INDESIT company

Model type:
IDL60SEU

Commercial code:
F030647

N1045072FIG1

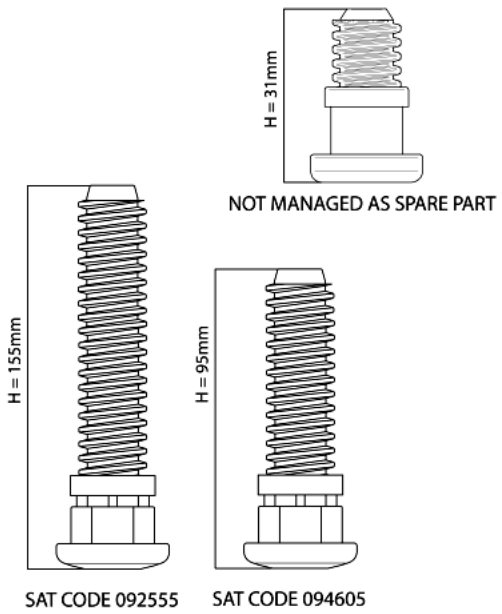
N1045072: Introduction of fixed rear foot H=31mm on free-standing models.

From serial no. 40218.0001, free-standing dishwashers affected by this modification have been equipped with new fixed rear feet (H=31mm).
The new foot replaces the adjustable one (H=155mm) Service code 092555; on the EVO3 range with TurboDry the new foot replaces the adjustable foot (H=95mm) Service code 094605.
The Spare Part Warehouse will continue to manage only 155mm and 95mm adjustable feet as they are interchangeable with the fixed 31mm foot.
The three feet are shown in illustration N1045072FIG1.

N1045083FIG1

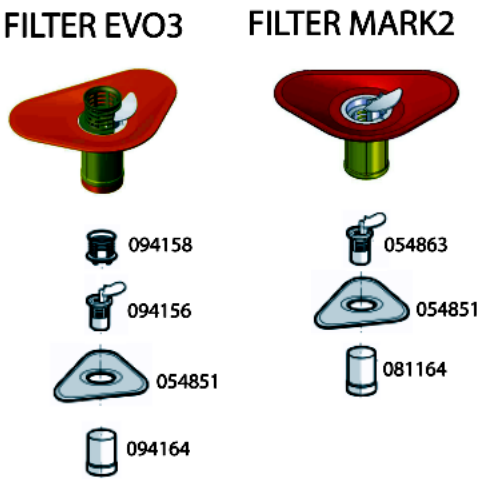
n1045083: Modification of filters on EVO3 60 cm dishwashers

All dishwasher models affected by this modification have been equipped with the items listed below, in order to solve the drain pump clooging problem.

Introduction of:
Cylindrical plastic filter code 081164
Central filter code 054863

Elimination of:
Cylindrical plastic filter code 094164
Central filter code 094156
Central filter grid code 094158

The modification has been introduced progressively, starting from serial no. 40516.0001.

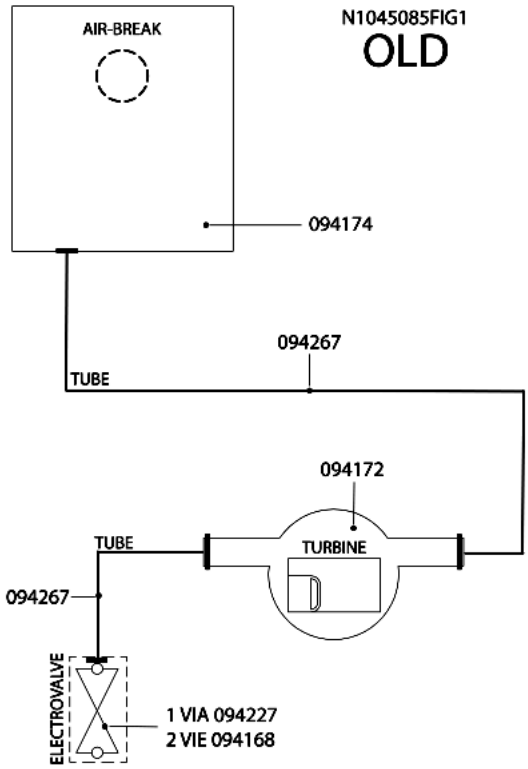
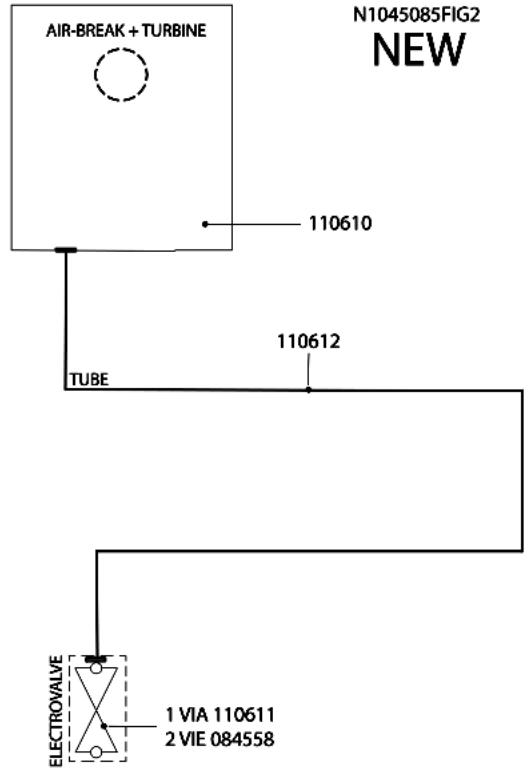
n1045085: Introduction of new litre counter turbine integrated on air-break.

All dishwashers affected by this note have been equipped with a new litre counter turbine on the air-break.
Picture N1045085FIG1 illustrates the premodification structure, picture N1045085FIG2 the new structure.

Items affected by the modification.

AIR-BREAK:
new 110610;
premodification 094174;
the new item features a new integrated litre counter turbine and its water supply hose has a smaller diameter.

LITRE COUNTER TURBINE code 094172 has been eliminated.

SOLENOID VALVES:
new:
1-WAY code 110611;
2-WAY code 084558(Rohs 143737);
premodification:
1-WAY code 094227;
2-WAY code 094168;
the new solenoid valves have a smaller diameter drain hose fitting.

HOSES:
new solenoid valve hose/air-break code 110612;
premodification turbine hose/air-break code 094267;
premodification solenoid valve hose/air-break code 094267;
the new hose has a smaller internal diameter.

WIRING:
the litre counter turbine connecting cable is longer, but since the connector is the same, the new item can be used in place of the premodification one.
